To: Timpte Dealer Parts and Service Personnel
From: Product Engineering
RE: **Parts and Service Bulletin #48**, 2018 Model Year Changes
Date: February 1, 2017

Timpte will be updating the 2018 Model Year Hopper Trailers with the following enhancements:

Stainless Steel Hardware standard for Landing Leg Mounting Bracket Installations

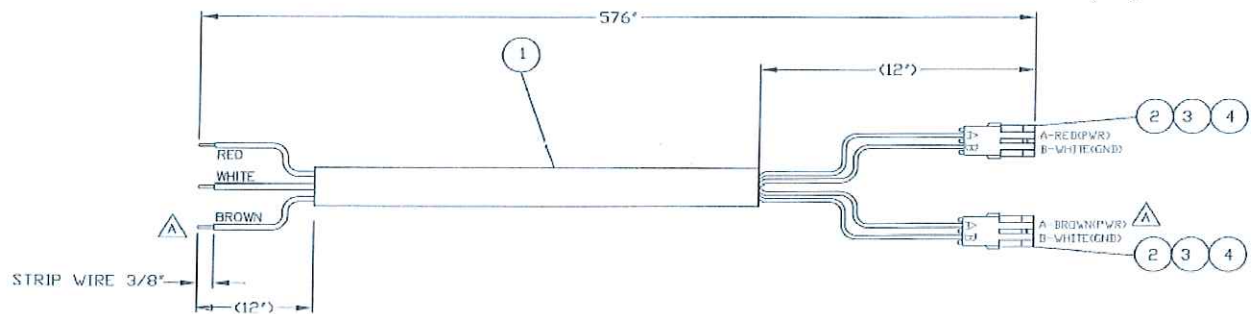
- #032-51826 SS $\frac{5}{8}$ -11 x 1 $\frac{1}{2}$ " Bolts
- #032-51827 SS $\frac{5}{8}$ " flat washers
- Continue to use #032-01407 standard zinc plated $\frac{5}{8}$ -11 nut for installation

Part Assembly for PPV Update

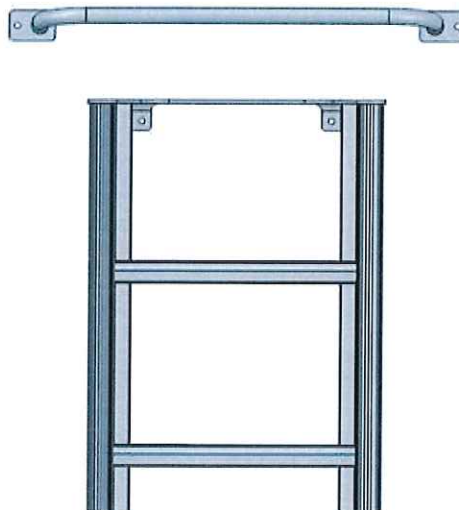
1. #021-38336, 1 ea. Fitting Nipple 3/8" Pipe x 2" Lg.
2. #021-57262, 1 ea. Fitting Connector Male 3/8 NPT – 3/8 Tube Push-lok
3. #024-59279, 1 ea. Pressure Protection Valve 3/8" Ports 70 PSI Close
